City of Portland, Maine - Building or Use Permit Application
389 Congress Street, 04101 Tel: (207) 874-8703, Fax: (207) 874-8716

Permit No:	01-027	Issue Date:	APR - 3 2011	CBL:	351 A024001
------------	--------	-------------	--------------	------	-------------

Past Use:	Single Family	Proposed Use:	Single Family; Add a roof and screen to existing deck to create a 12' x 14' screen room. Call Contractor when ready.	Permit Fee:	\$54.00	Cost of Work:	\$4,000.00	Area	2
Proposed Project Description:	Add a roof and screen in existing deck to create a 12' x 14' screen room.			FIRE DEPT:	<input type="checkbox"/> Approved <input type="checkbox"/> Denied	INSPECTION:	Use Group: R-3 Type: 513	300 APR 15 2011 WITH REQUIREMENTS

BUILDING PERMIT REPORT

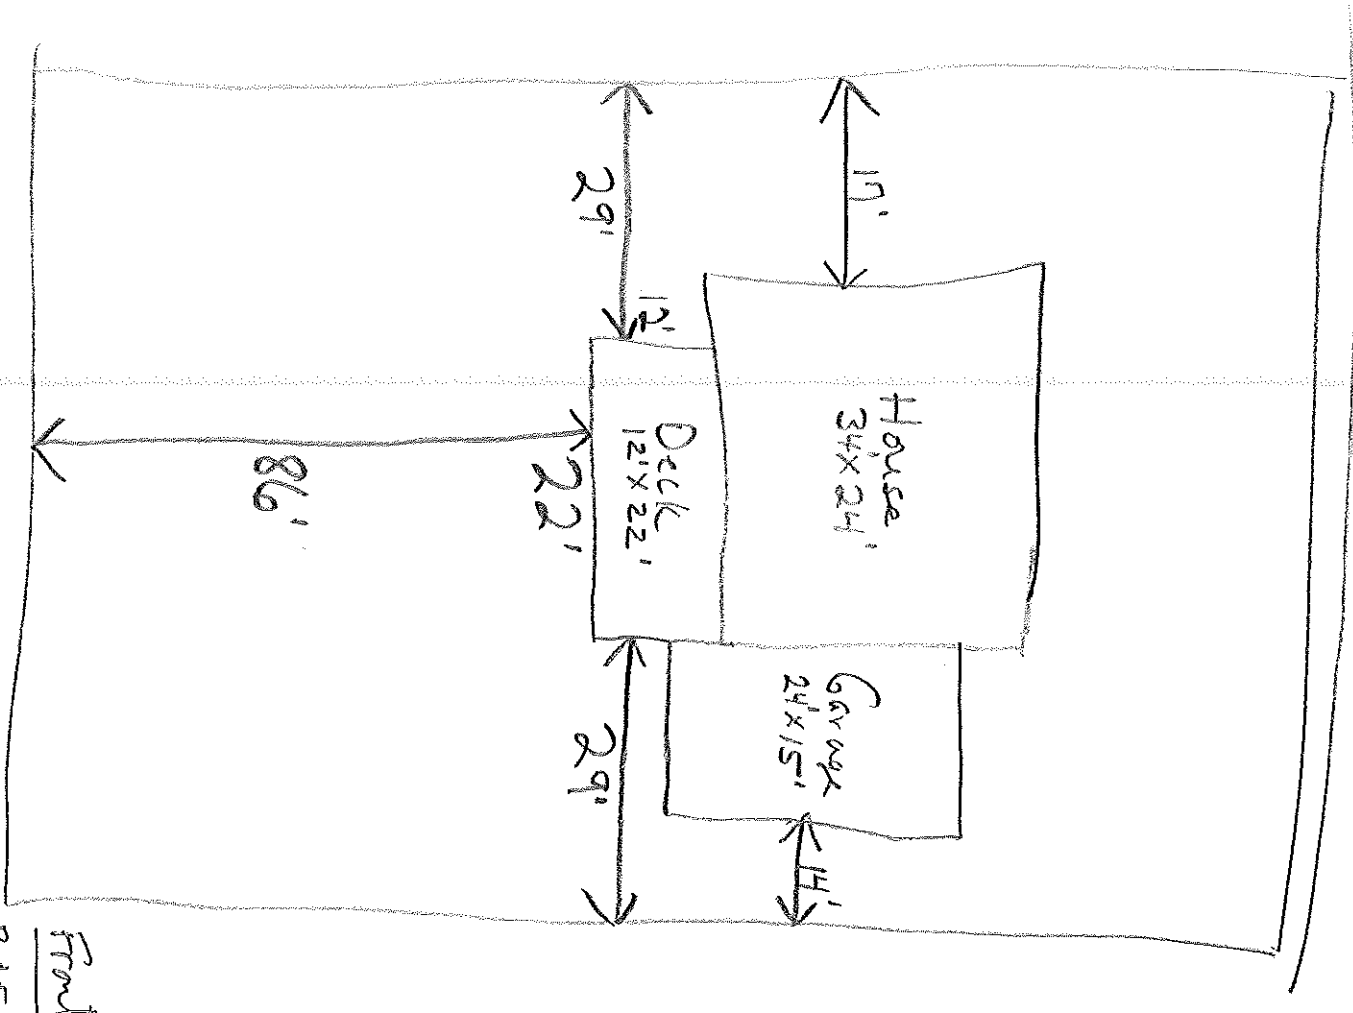
Front: N/A

REAR: 25' req - 86' shown

Sides: 12' req - 29' shown

OK 351-A-24
